**Name:** Morné de Jager  
**Cell:** 082 565 4059  
**E-mail:** morne@menco.co.za  
**Date:** 6 June 2019  
**Ref:** Korana WEF

**SPECIALIST STUDY: NOISE IMPACT ASSESSMENT: PROPOSED KORANA WIND ENERGY FACILITY SOUTH OF POFADDER: CHANGE OF WIND TURBINE SPECIFICATIONS**

Figure 1: Locations of wind turbines as evaluated

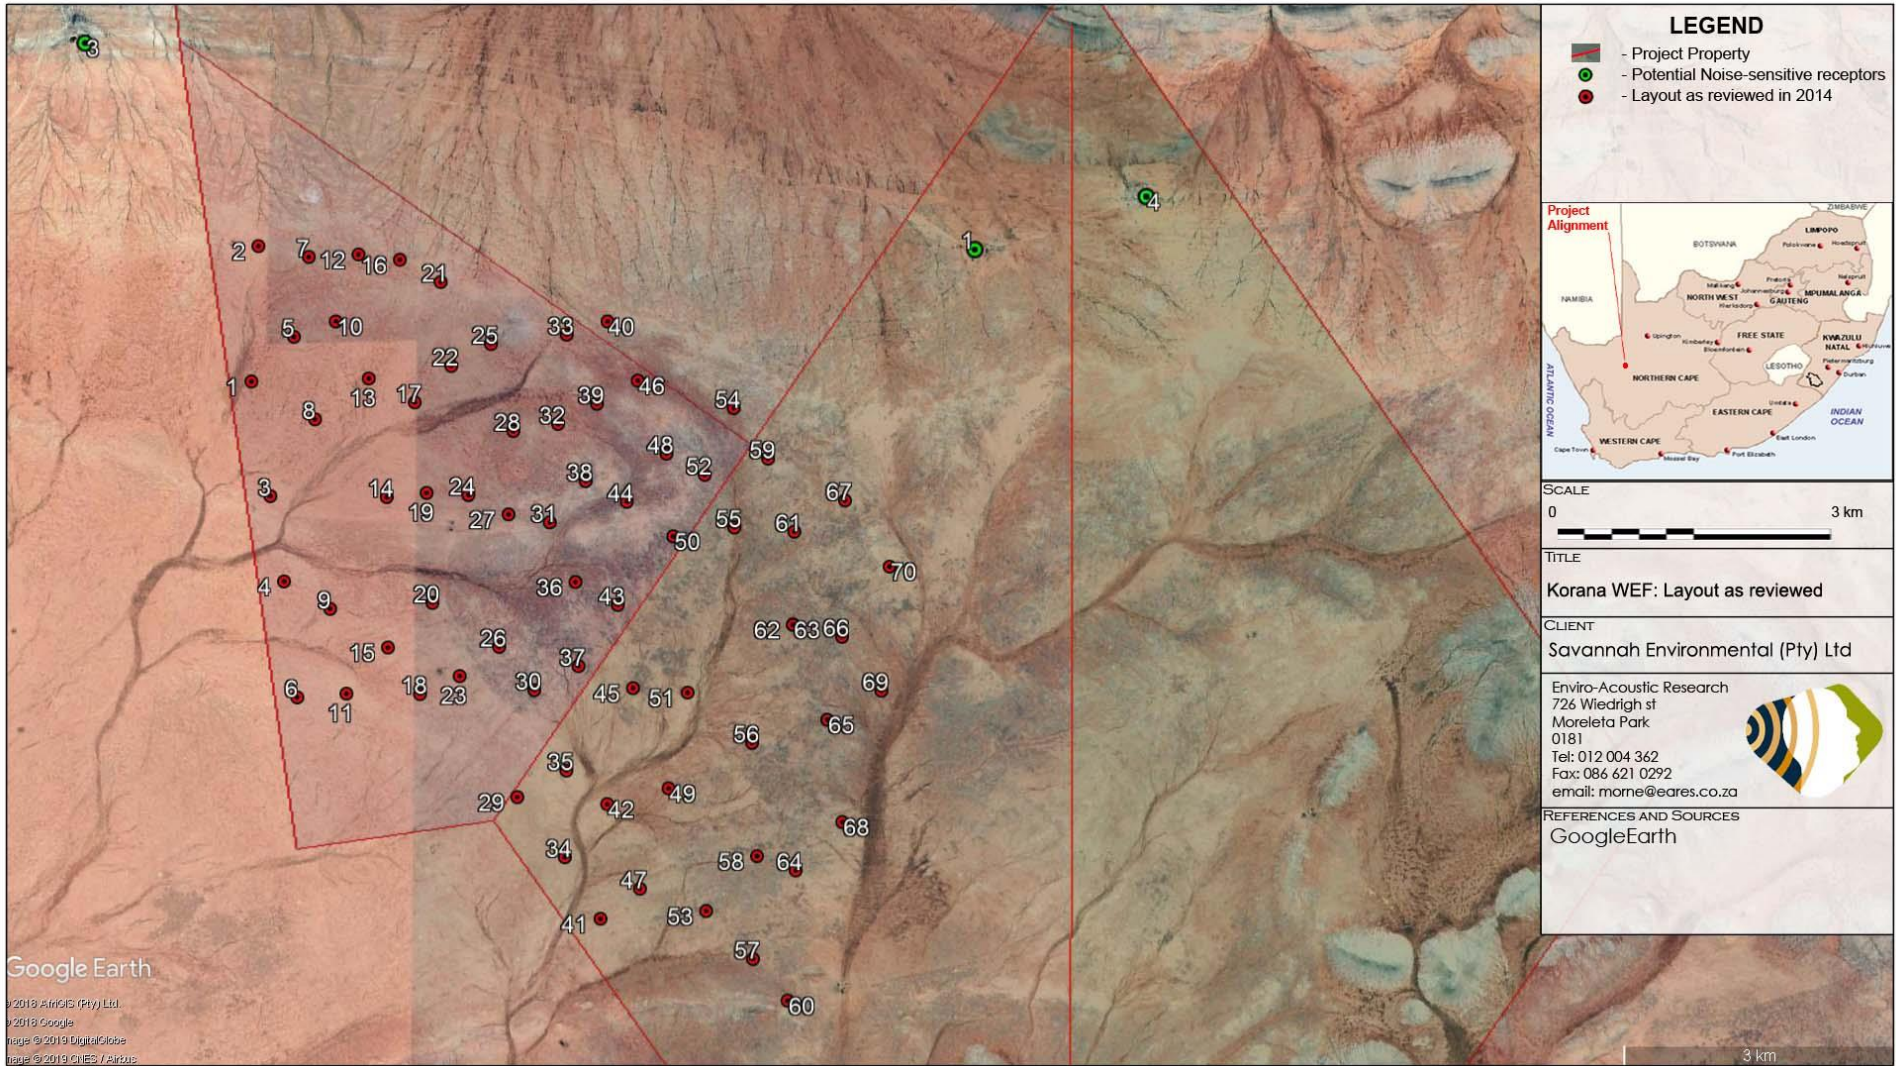
All of the proposed wind turbines are further than 2,000m from any potential noise-sensitive receptors and even with the higher potential sound power emission level (worst-case of 109 dBA), the maximum projected noise level will be less than 35 dBA at the closest NSD.

Considering the location of the wind turbines and the potential noise impact, it is my opinion that the change will not increase the significance of the noise impact. A full noise impact assessment with
